## Determination 2018/051

# The refusal to issue a code compliance certificate for a 9-year-old house with mixed claddings at 170 Pukehina Parade, Te Puke

**Figure 1: Approximate site plan**

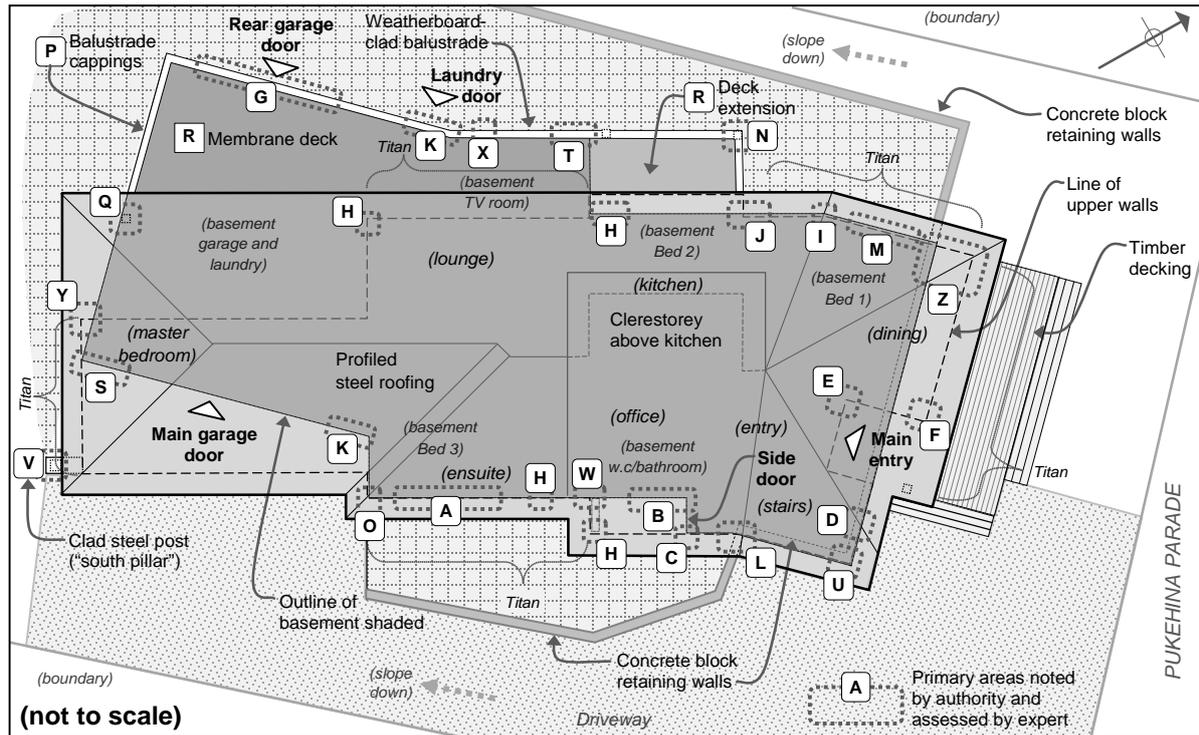
- Ends of head flashings (Areas A, B, D, E and F).
  - Bottom of cavities (Areas C, H, and O).
  - Condition of sheet cladding (Areas M and D).
  - Ground clearances (Areas K, L, N, S and Z).

- Deck membrane, junctions and balustrades (Areas J, P, R, Q and Y).
  - Joinery jamb/cladding junctions (Areas C, G, K, S and T).
- 3.5.3 In a letter to the applicants dated 18 January 2018, the authority refused to issue a code compliance certificate for the house, noting the meeting with the second building surveyor and stating:

- face sealed vertical joints in sheet cladding in lieu of back sealing
- drained cavities not installed to:
  - inner side of balustrades
  - southeast side door wall (Area C)
  - garage south corner column (Area V)
  - deck extension columns (Area N)

- 18% beside the side door (Area C)
- 22% in the south corner bottom plate of the garage (Area S)
- 26% to the post under the deck extension (Area N)
- 60% to the bottom plate of the south pillar (Area V).

- Head flashing/cladding junctions (A, B, E, F, G):
  - there are some 3-5mm drainage gaps above head flashings
  - head flashings with no stop ends extend about 30mm past jambs
  - some ends butt against cavity battens, which act as stop ends
  - some ends are exposed and poorly sealed (Areas A, C, E, F)
  - some ends are poorly sealed but well sheltered (Area B)
  - rear garage door lacks drainage gap above head flashing (Area G)
  - bedroom 1 flashing has unsealed end and gap at socket junction (Area M).

- bedroom 3 jambs have some 1mm overlap and lack seals (Area A)
  - TV room jambs have overlaps but no seals (Areas X, T)
  - some jambs have unsealed gaps at socket joints (Areas A, C, K, T)

- main garage door has unsealed jamb junctions and large gaps at recessed socket joints (Area S)
  - rear garage door has jamb facings but gaps at socket joints (Area G).

- Bottom of sheet cladding cavities (Areas H, and T):
  - Fibre cement cavity battens generally protrude through the cavity closers, rather than terminating above proprietary plastic vent strips as shown in drawings

- there is no cavity to the short wall beside the rear door, which should not be a problem if unsealed head flashing and jamb are repaired (Area C)
  - lack of cavities to ground-treated posts under deck extension should not be a problem (Area N)

- the steel post supporting upper south corner is framed and clad to form decorative pillar, with sheet cladding direct-fixed against building wrap and evidence of moisture entry and damage to framing (Area V).

- Condition of sheet cladding (Areas I, J):
  - there is a short unflashed horizontal junction at the head flashing (Area I)
  - there is a small diagonal crack at end of the head flashing (Area J)

- cladding with insufficient clearance is exposed beside the retaining wall so attention is required (Area L)
  - at northwest cladding to dining area, the cladding extends over the subfloor down to the mowing strip – risking moisture transferral via the adjacent retaining wall into the adjacent basement cavity (Area Z)

- direct-fixed cladding to posts supporting the deck extension butts against paving and moisture levels were elevated – although timber drillings appeared ‘in excellent condition’ with no indication of damage (Area N)

- there are unsealed pipe penetrations below the hot water unit (Area L)
  - the meter box lacks an effective head flashing (Area X).

**Figure 2: General details in consent drawings**

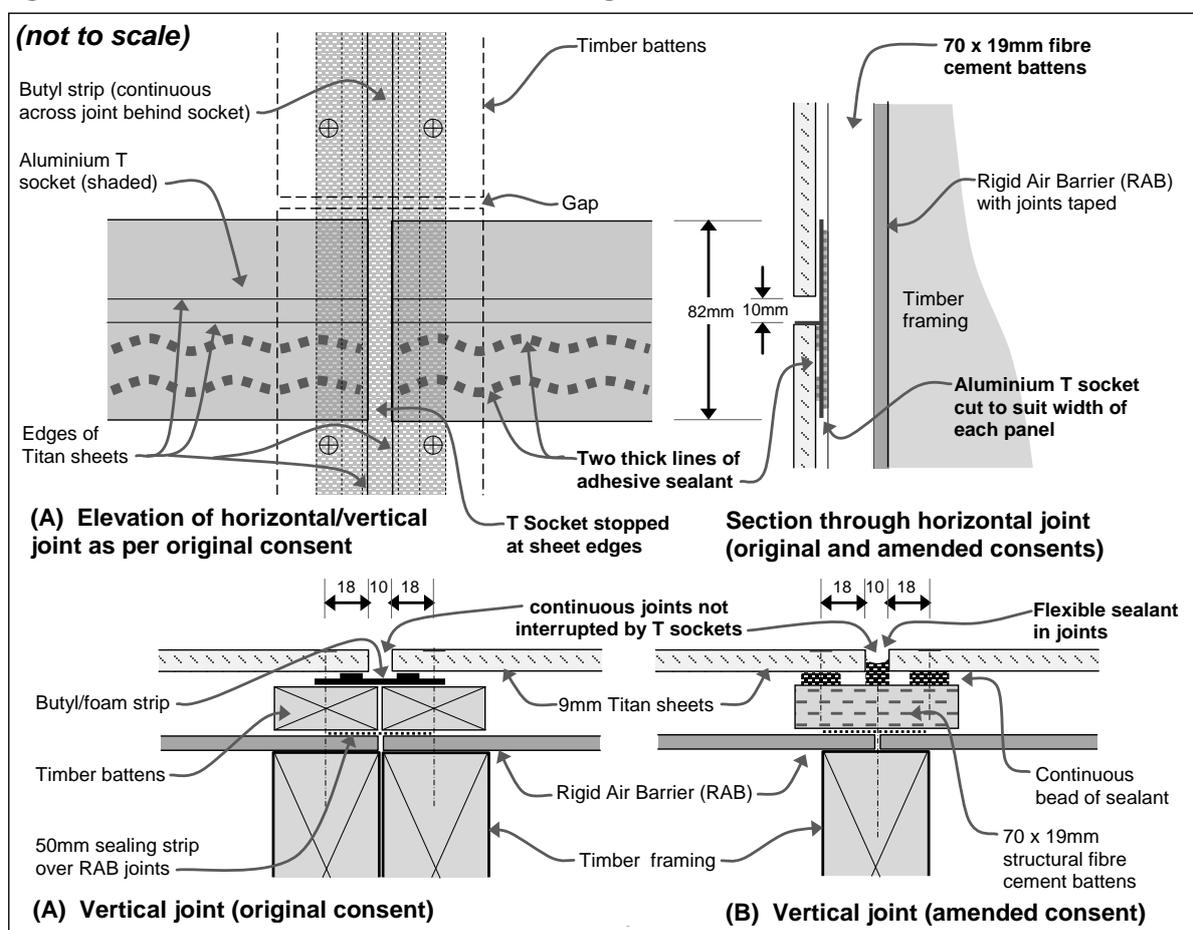
- 2.7.2 The 2008 consent documentation included the manufacturer’s specification for the sheet cladding and the drawings included details from those specifications as shown in Figure 2(A) but the cladding was installed using structural battens and face-sealed joints. Amended vertical joints as shown in Figure 2(B) were retrospectively approved under the 2011 consent amendment.
- 2.7.3 The remaining walls are clad in 16mm thick proprietary horizontal fibre cement weatherboards fixed through battens and the building wrap to the framing timbers.

(I note the horizontal flange of the ‘T’ socket continues over the vertical corner joint in contrast with Figure 2(A).)

- vertical joints are face-sealed as shown in Figure 2(B), rather than incorporating underlying seals as shown in Figure 2(A)
- face sealing does not appear critical but requires increased maintenance, with some sealant gaps currently requiring attention (Area M)

- inspection and destructive investigation revealed that:
  - T sockets had not been cut to suit panel width – instead the socket continues across vertical sealant joints, interrupting free drainage in recessed joints

- a single bead of sealant had been applied, with gaps to some areas that allow water to penetrate behind the top of the lower panels
  - water running down the vertical sealant joint would also track along horizontal flange where the T socket crosses the joint, so increasing amount of water able to penetrate the top of the lower panels.
